Javier Barrera
Deforma Studio
5555 Biscayne Blvd Suite 2SW
Miami, FL 33137

RE: 2nd Round Pre-App Comments for 200 N Federal Highway, Pompano Beach, FL

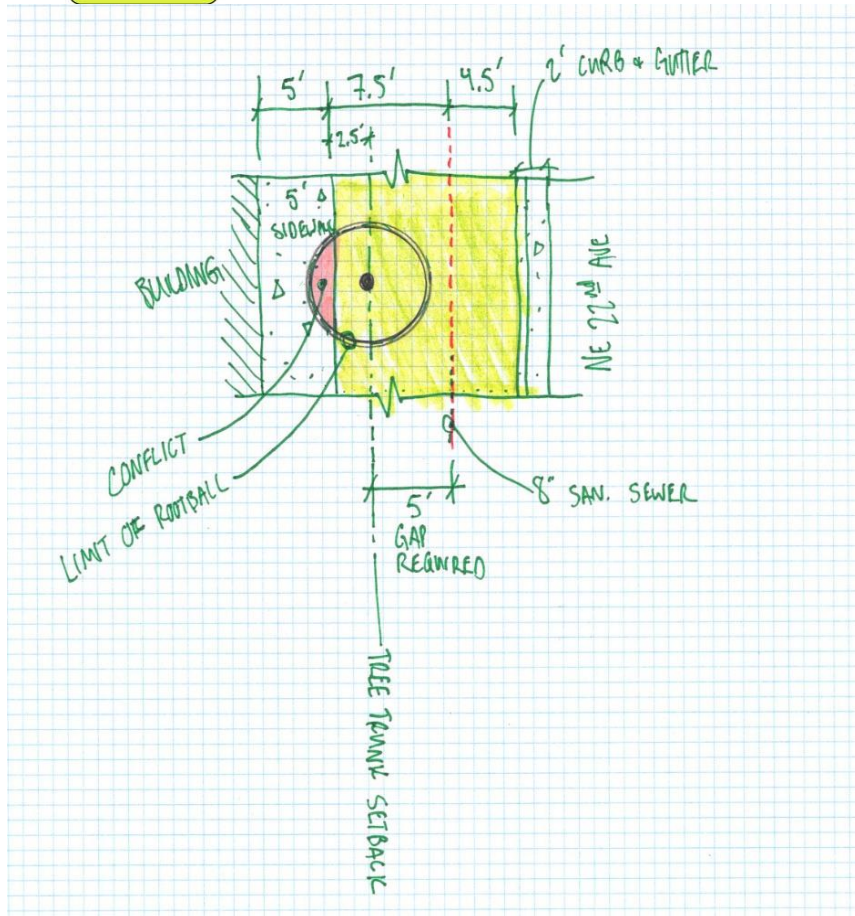
7. Please show the 5 middle trees along NE 22 to be the large Oaks. Silver buttons do not meet the requirements. On street parking is not required, however the trees are, please adjust to meet the minimums and size.

Plans updated to include Oaks along 22nd Ave; however, Oaks will need to be field verified prior to installation because even if removing the on-street parking, the 24' there is an 8" Sanitary Sewer running up the middle of the planter that we need to be 5' away from (as required by Utilities review). Large, 24' Oaks might not have rootballs that will fit. Oak rootballs need to be small enough to have a rootball under 5' wide. Here is a sketch to illustrate the problem (1/10"=1'-0" grid FYI):
